CITY OF TAYLOR, TEXAS PLANNING AND ZONING COMMISSION MEETING

August 8, 2023, 6:00 P.M.

**City of Taylor
PZ-2023-1633
3811 N. Main St.
Subdivision Improvement Plans
Staff Report**

Staff has completed its review of plans for the 3811 N. Main St. Subdivision Improvement Plan that is to be located at 3811 N. Main St., Taylor, TX 76574. At this time the plan set has been Denied based on staff comments below. Please coordinate with Shai Roos to set up a Comment Resolution Meeting. Please be aware that the next resubmission date will be on August 18th.

TOWNHOME PUBLIC UTILITY
EASEMENTS (P.U.E.)
-TOWNHOME BLOCKS 11 & 12
LOT 1

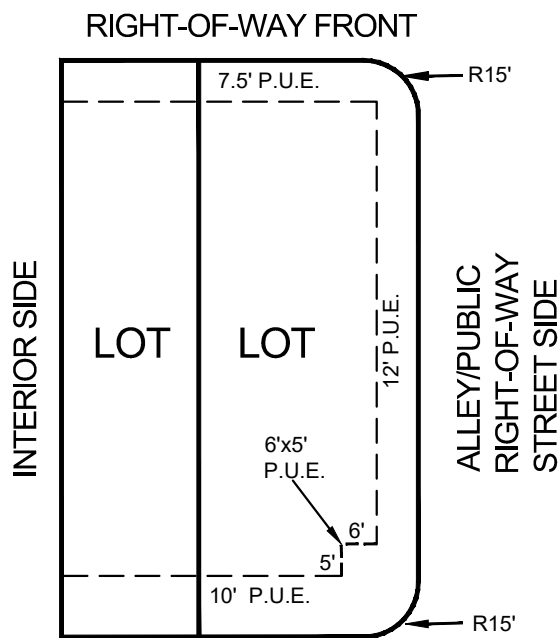
1. Lot 1 inset - Remove "Public ROW" from text.
2. Label "Rear" on both insets. Provide separation from heading text.
3. Lot 16 inset - Remove "Alley" from text.

RCR-TAYLOR LOGISTICS PARK FINAL PLAT, PHASE 2, BLOCKS 3-6

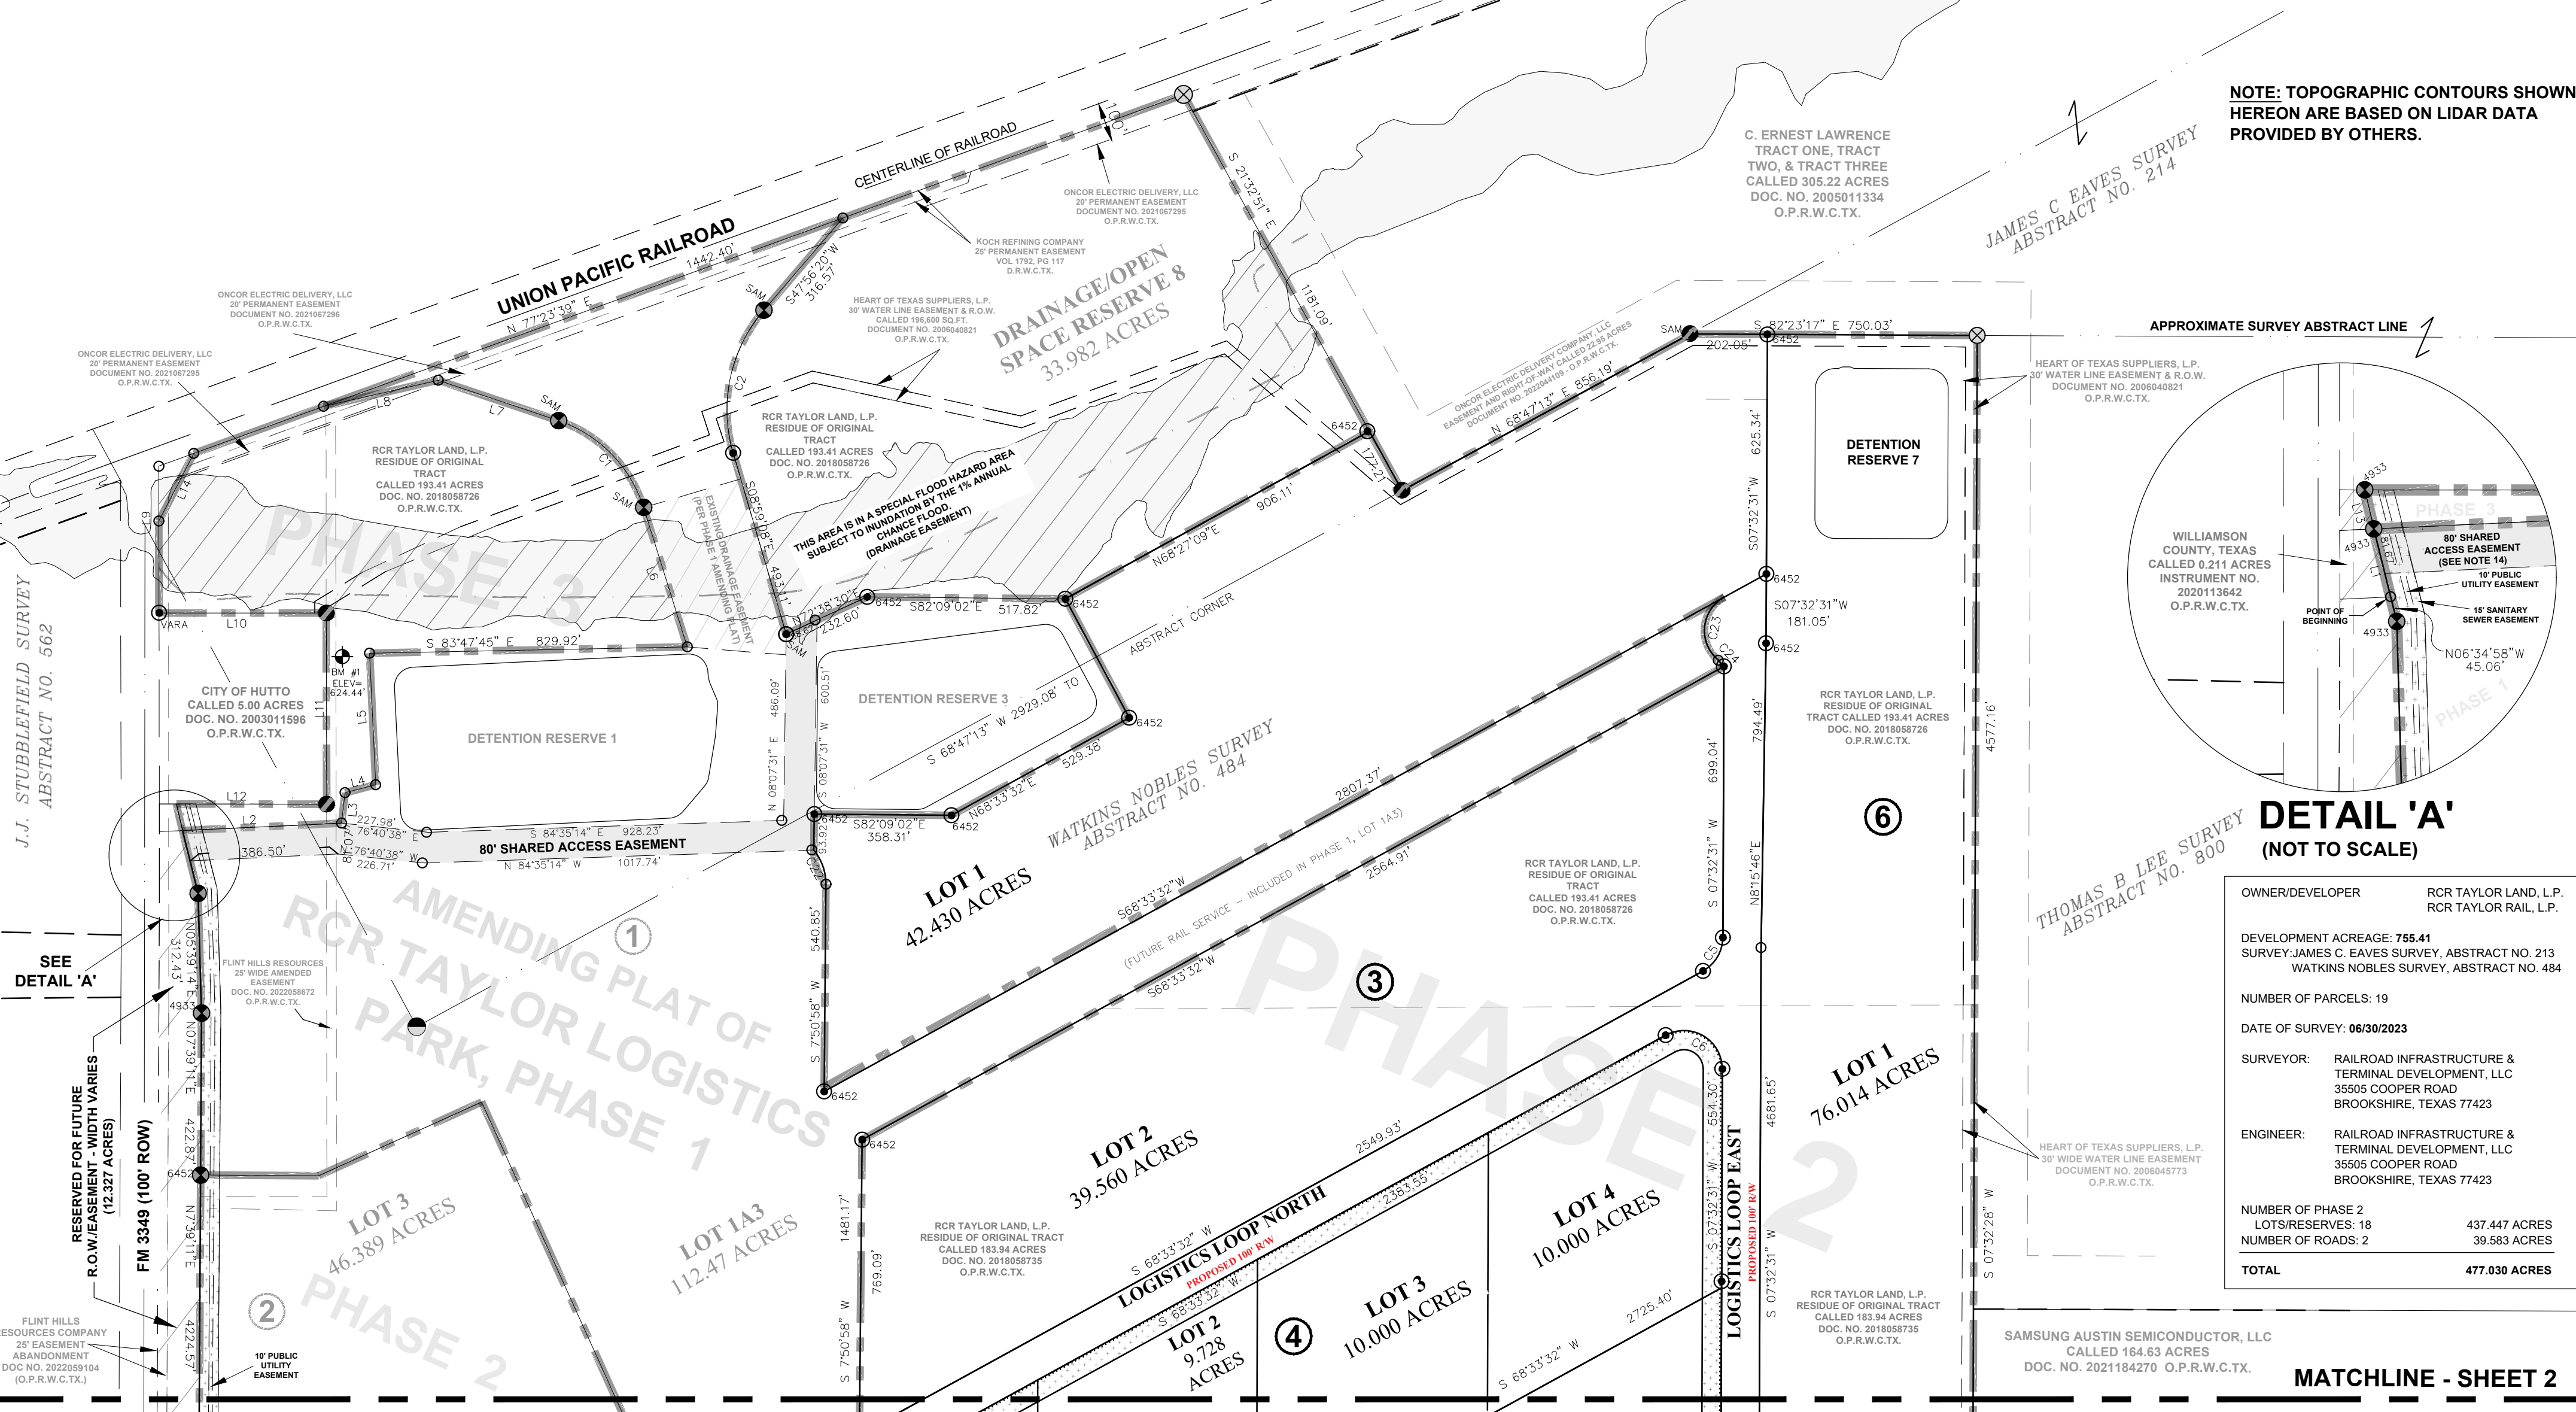
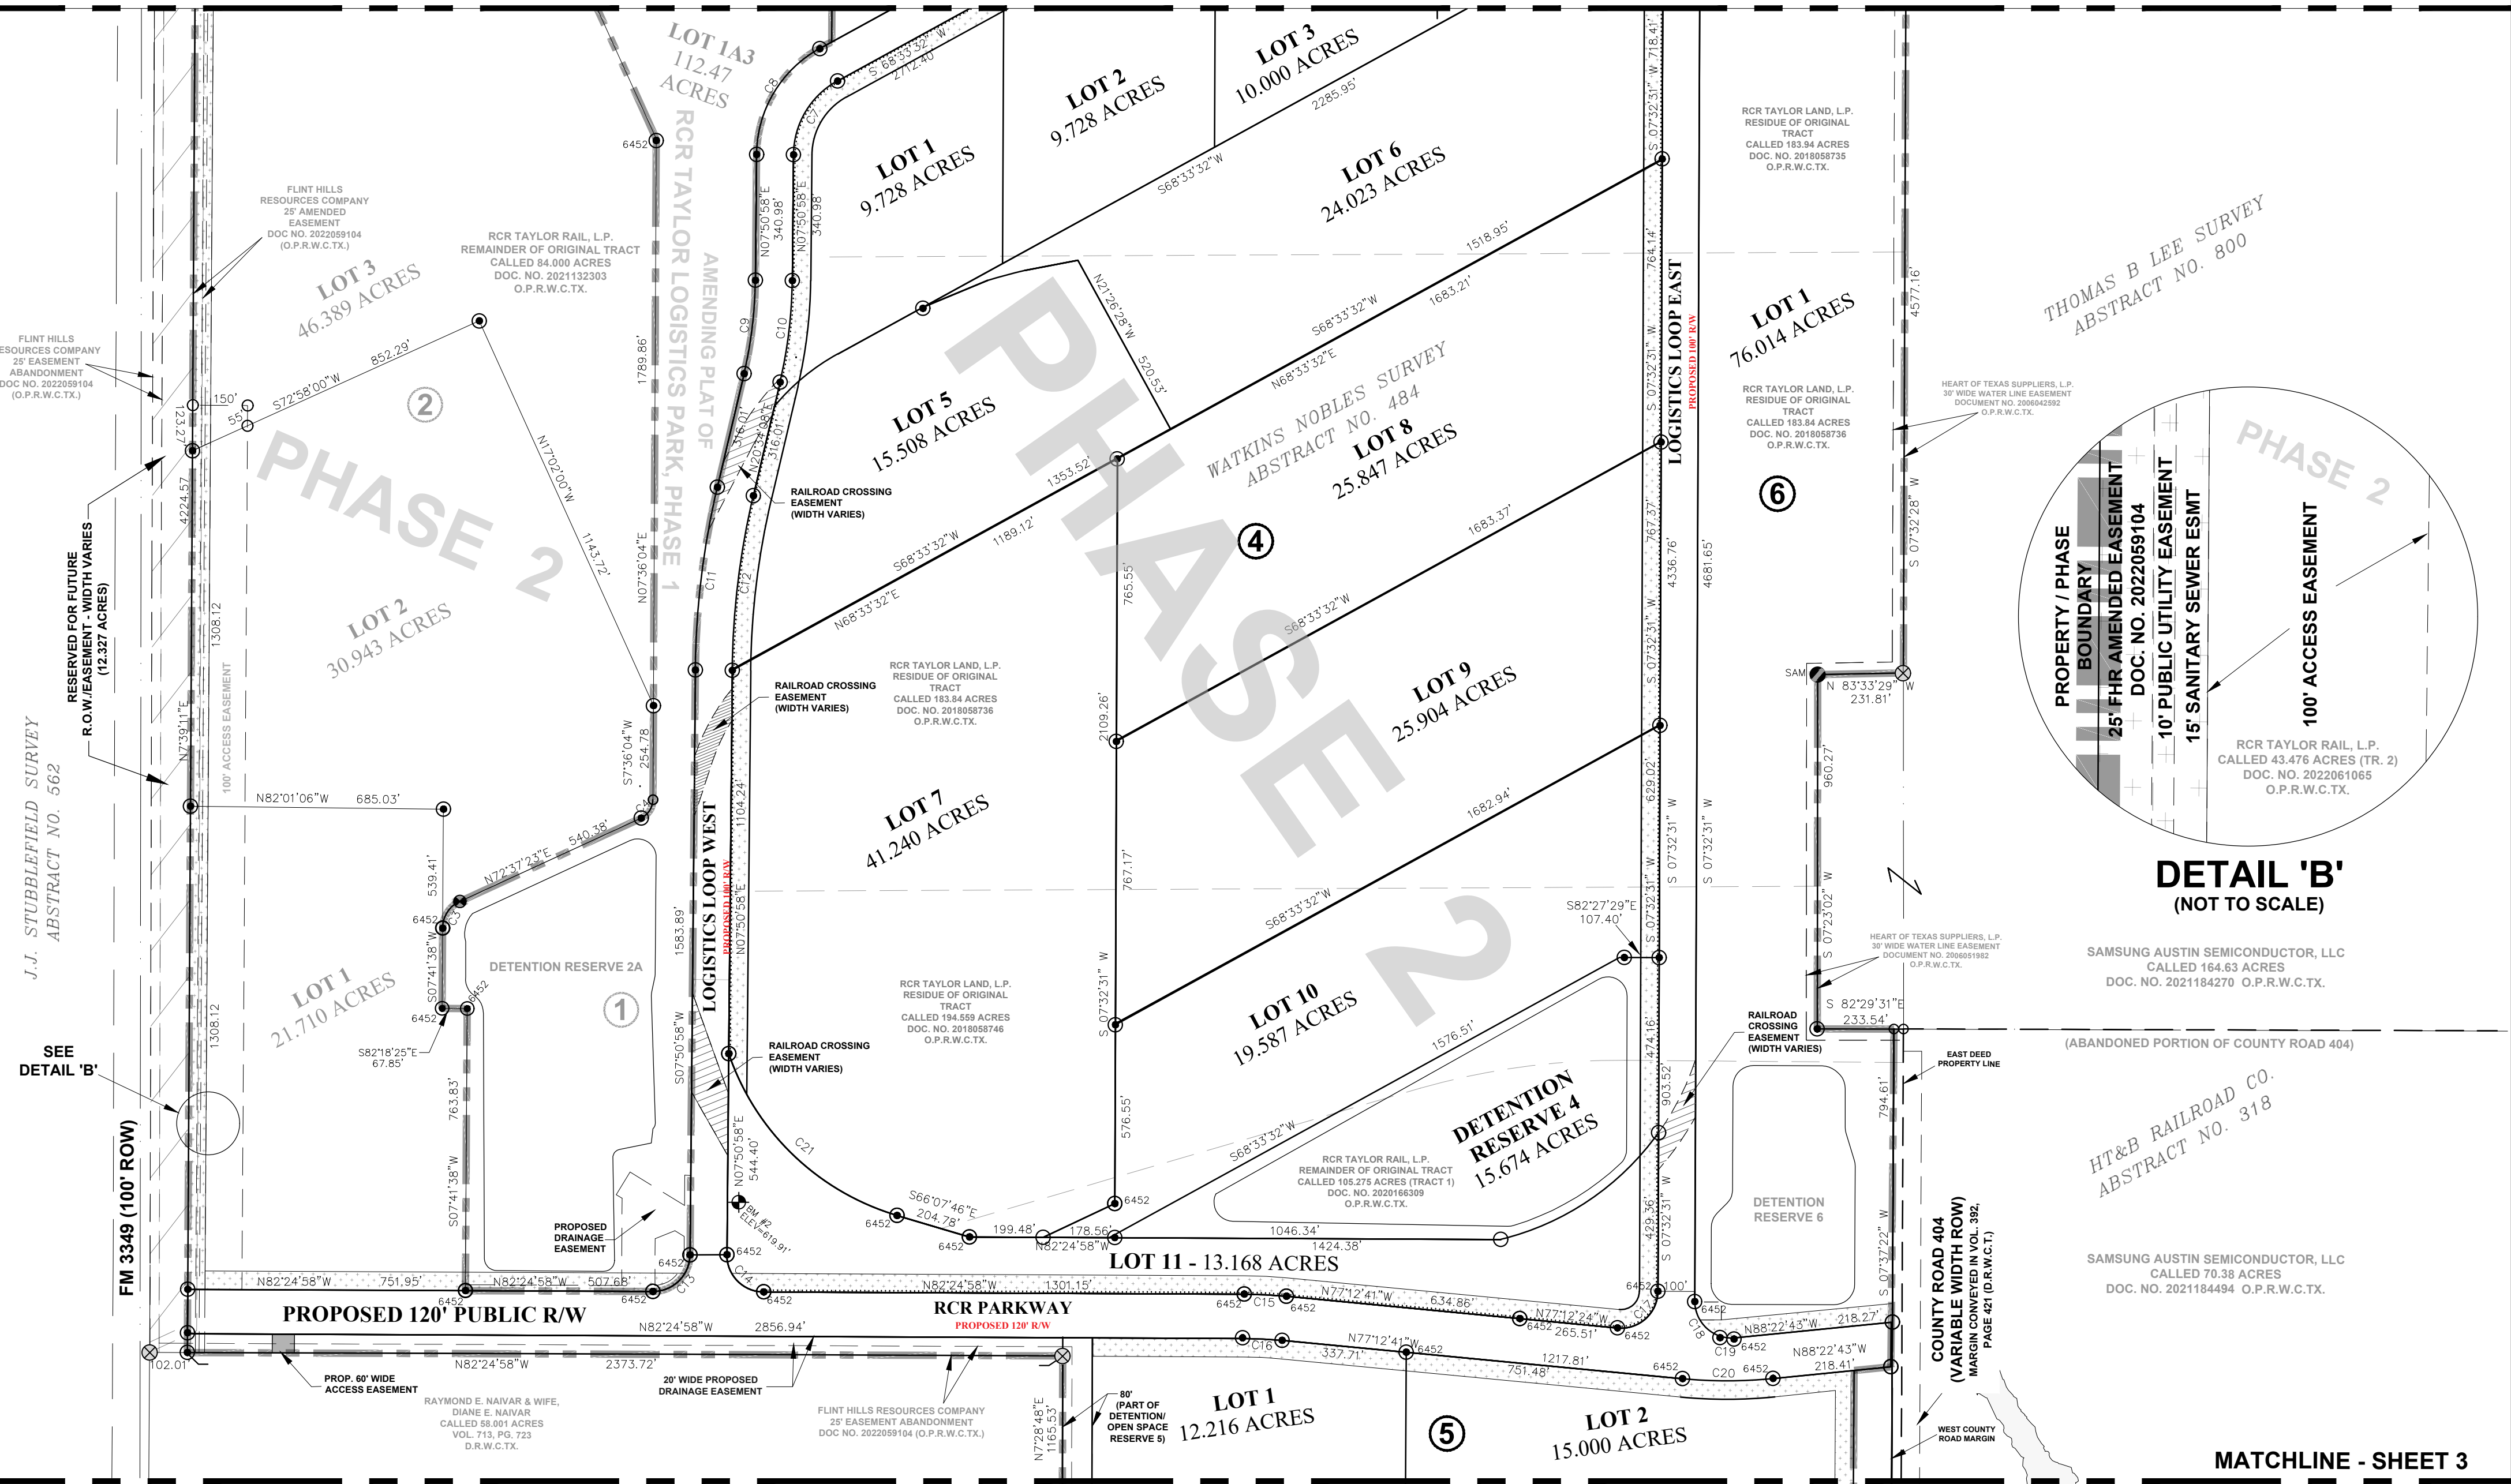
1. Sheet 1 of 4 - Provide a table showing linear feet of new streets, including type of street (e.g. thoroughfare type)
2. Sheet 1 of 4 - Provide a table showing lot and block details, broken out by phase.

3. Sheet 1 of 4 - Verify if private water line easement is needed for Lot 1 Blk 3
4. Sheet 1 of 4 - Show location of all existing railroads within the plat per Subdivision Ordinance Sec. 3.3 (Typical).

5. Sheet 1 of 4 - Update text shown under Logistics Loop callout
6. Sheet 1 of 4 - Please verify all applicable easements are shown along the adjacent Samsung subdivision including force main easement.

7. Sheet 1 of 4 - Verify note, no contours shown.
8. Sheet 2 of 4 - Update text shown under Logistics Loop callout
9. Sheet 2 of 4 - Update text shown under RCR Parkway callout

10. Sheet 2 of 4 - Provide callout/inset for proposed lift station easement
11. Sheet 2 of 4 - Verify what area this is and provide a dimension for this sheet

12. Sheet 2 of 4 - Verify continuity of easement and reserve 2a for outfall pipe
13. Sheet 3 of 4 - Verify what area this is along CR 404
14. Sheet 4 of 4 - Verify use of the OSSF signature. With the subdivision improvements, this section should have sewer service

15. Sheet 4 of 4 - Plat title to match certificates
16. Sheet 4 of 4 - Provide the minimum finished floor elevation on affected lots
17. General - Verify proposed 60-ft access easement for Naivar property is final or requires relocation based on roadway layout of RCR Parkway.
